Docket: NRC-2010-0131
AP1000 Design Certification Amendment

Comment On: NRC-2010-0131-0001
AP1000 Design Certification Amendment

Ramifications for the AP1000 Containment Design

- Figure 1 – AP1000 in normal operation.
- Figure 2 – AP1000 design basis accident begins.
- Figure 3 – AP1000 containment hole opens as containment fills with radioactive gases.
- Figure 4 – AP1000 chimney effect draws radioactivity directly into the environment.

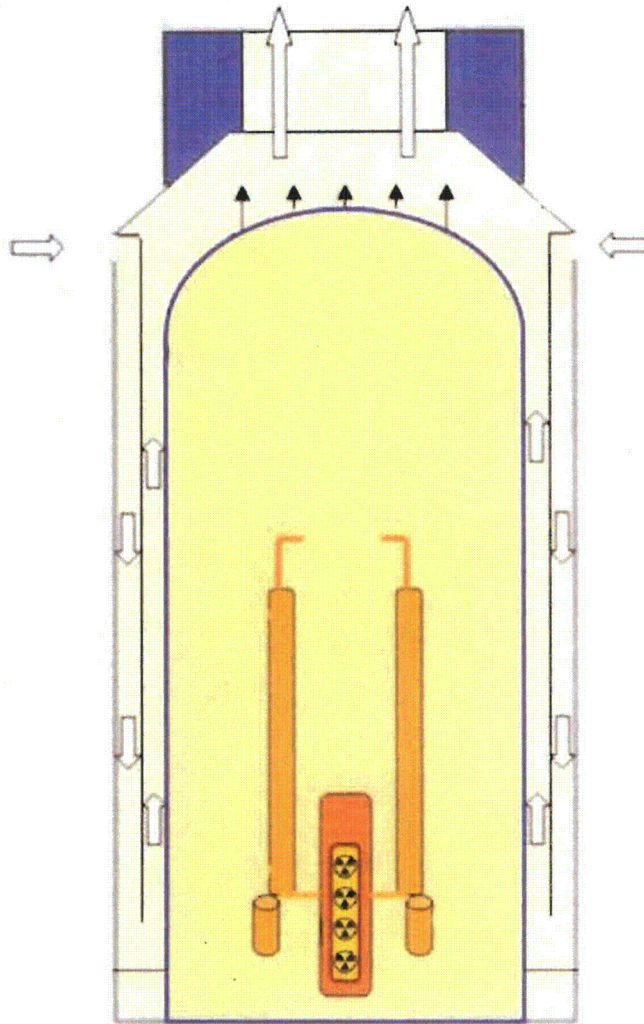
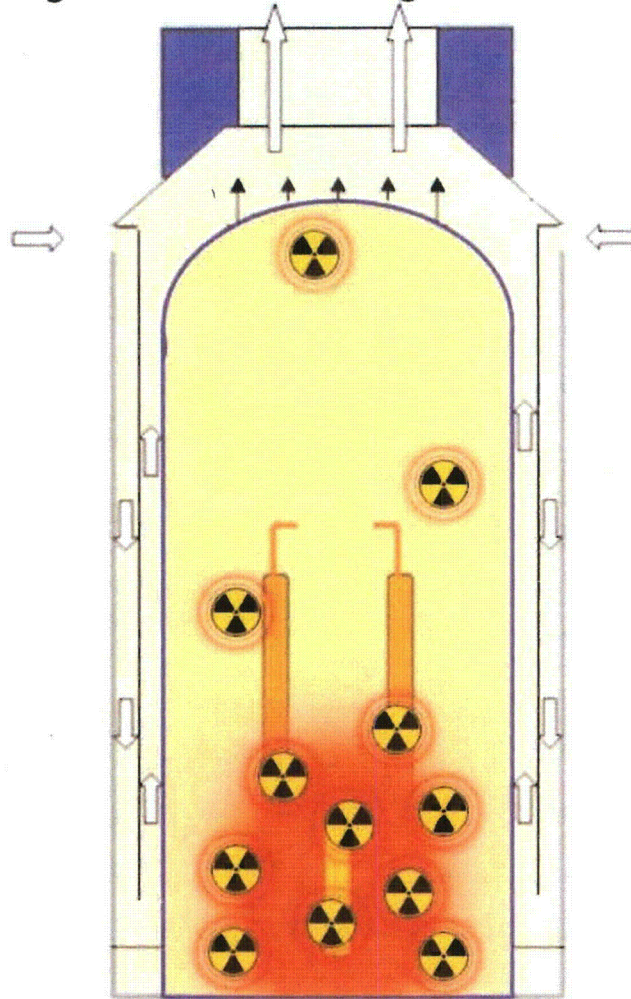
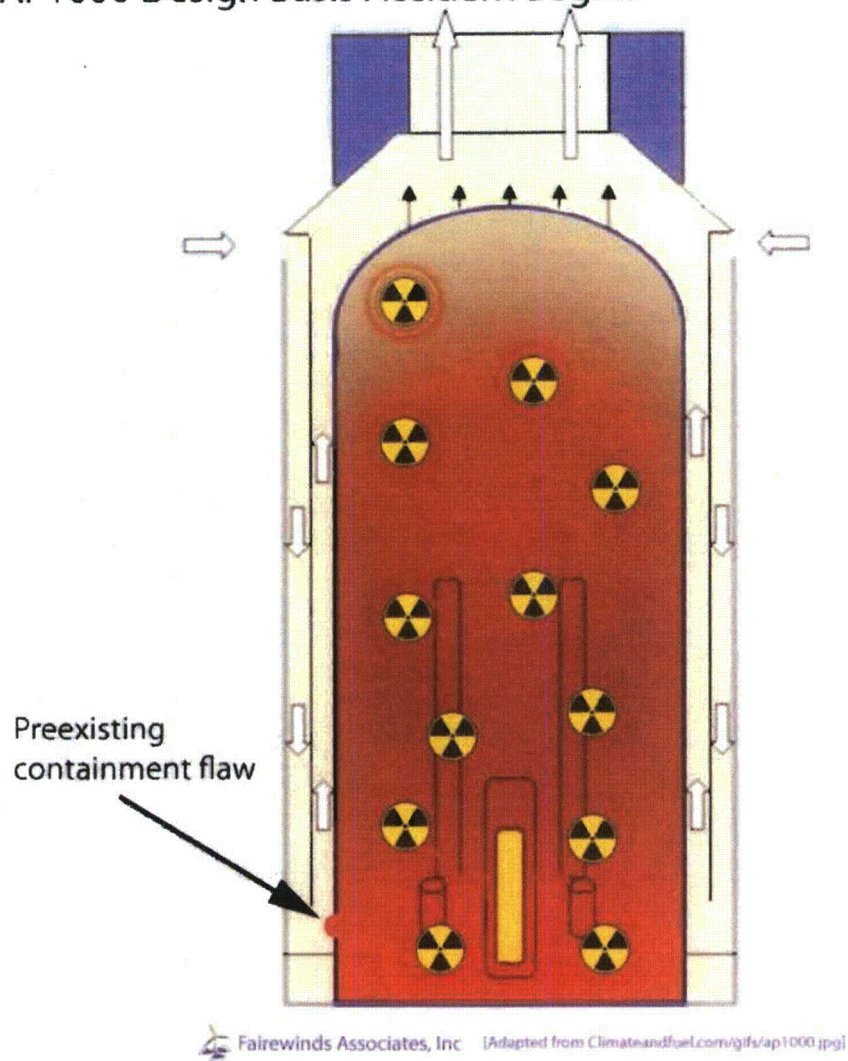
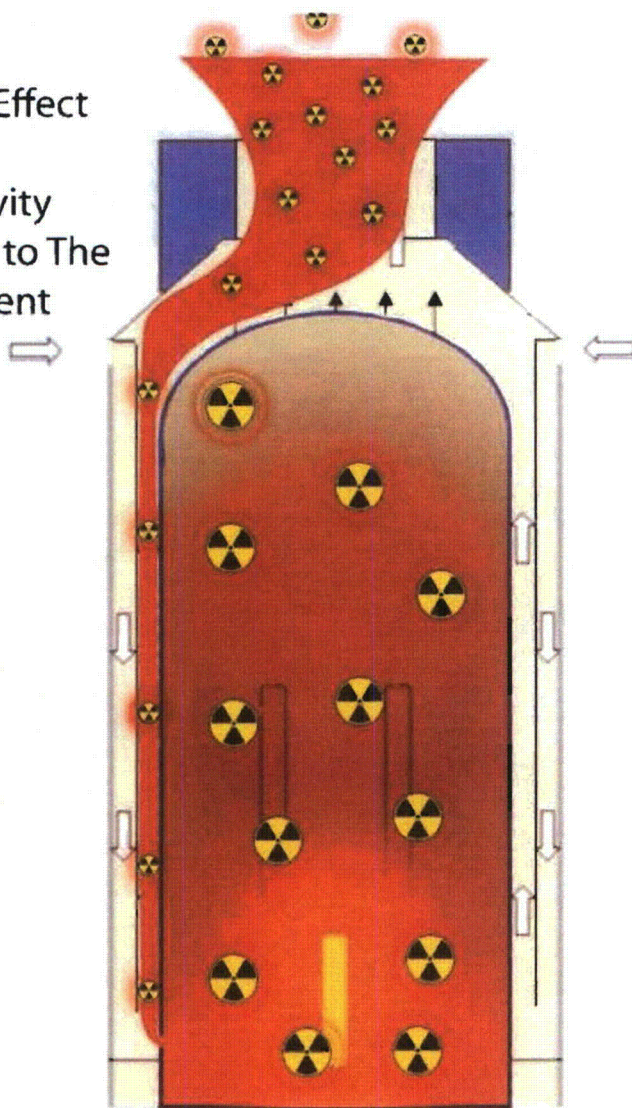
3.2.8 Implications To The AP1000 Design. The ACRS concern regarding containment integrity following the discovery of the Beaver Valley hole, Dr. Petrangeli's concern with respect to new containment design leakage rates, and the detailed history of at least 77-containment system failures nationwide, demand a wholly new analysis to determine exactly how the newly proposed AP1000 design accommodates leakage through the wall of its unique hybrid containment system.

Containment system leakage from through-wall holes in steel has already occurred at North Anna, Beaver Valley, Hatch 1, Hatch 2, Cook and Brunswick. However, in each of these circumstances ACRS member Shack articulated the fact that there was another potential barrier by which to collect and filter the airborne radiation that leaked from the containment system. Previous freestanding steel containments with holes were enclosed within a reactor building into which the leakage entered and was controlled. The liner failures appeared to be backed up by a concrete containment building.

In the event of an accident at a proposed AP1000 reactor, leakage through the freestanding steel containment will pass directly into the gap between the steel and the shield building. Therefore, the proposed AP1000 containment design is inherently less safe than current reactors presently licensed and operating.
